# Bath Flood Risk Review of Previous Flood Management Reports

Report EX6679  
Release 1.0  
December 2011

<b>Project</b>	Bath Flood Risk
<b>Report title</b>	Review of Previous Flood Management Reports
<b>Client</b>	Duchy of Cornwall
<b>Client Representative</b>	Nick Pollock
<b>Project No.</b>	MAM6777
<b>Report No.</b>	EX6679
<b>Project Manager</b>	Mike Briggs
<b>Project Director</b>	Steven Wade

HR Wallingford was appointed in November 2011 by the Duchy of Cornwall to review recent reports discussing flood management issues for the River Avon in the Bath area. The review particularly focuses on a report entitled “*Bath Compensatory Storage study*” (prepared by White Young Green (WYG) in November 2011) and on a report entitled “*Bath and North East Somerset Flood Risk Management Strategy Report*” (prepared by Atkins in June 2010).

**Figure 6.1 Compensatory storage requirements**

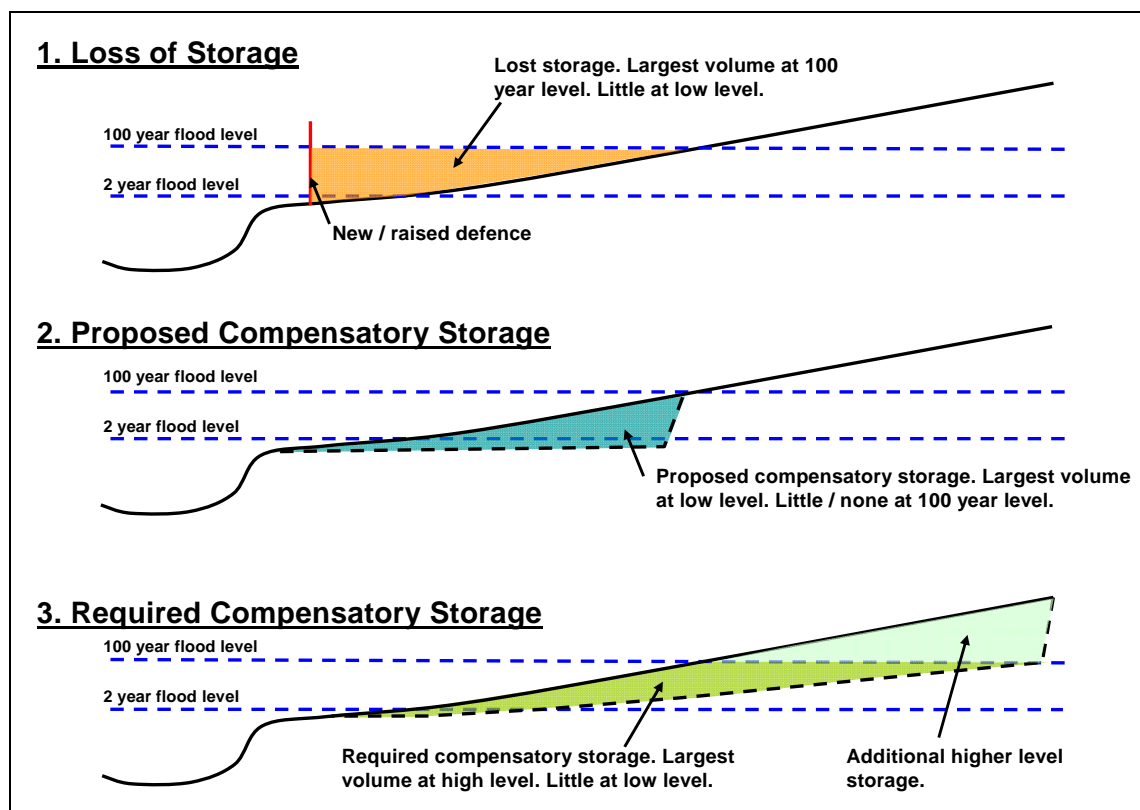
In the case of all of the three sites that were considered in detail, the difference in peak water levels between the 1 in 2 year and 1 in 100 year plus climate change events was at least 3m. Any storage to be provided to compensate for lost storage at the 100 year level should therefore be 3m or more above that provided for the 1 in 2 year event. However, this is not what is proposed.

Figure 6.1 illustrates the loss of storage, the proposed provision of compensatory storage and what should be provided.

The first diagram illustrates that where there are new or improved defences there is normally a small volume of existing floodplain storage lost at lower levels, whereas the volume lost at higher levels is relatively large.

Thus, the principle of compensatory storage is accepted, but it is important that the details are correct, to avoid any deterioration of flood risks.

**Figure 7.1 Potential upstream storage sites**

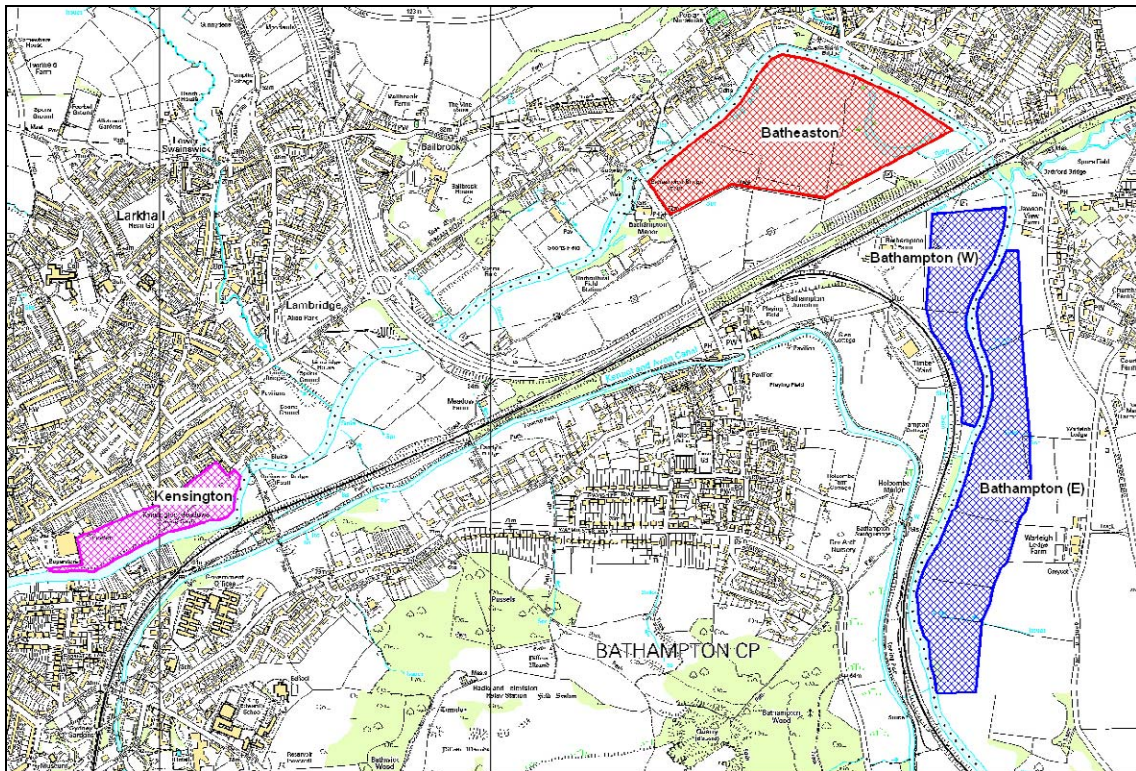
WYG initially considered eight possible storage locations, seeking to identify preferred sites for more detailed assessment. Five sites were discounted due to insufficient storage capacity relative to the associated costs and to potential planning issues. The remaining sites were at Kensington Meadows, Batheaston and at Bathampton. These are shown on Figure 7.1.

Whilst there is a significant volume potentially available at lower levels there is no storage volume available near the 100 year level. This site could therefore provide some benefits at lower levels, but none at higher levels.

The Kensington Meadows is a local nature reserve, with areas of fen and woodland and it supports a diverse population of plants and animals, being used by otters, bats and kingfishers. A detailed ecological assessment will be required.
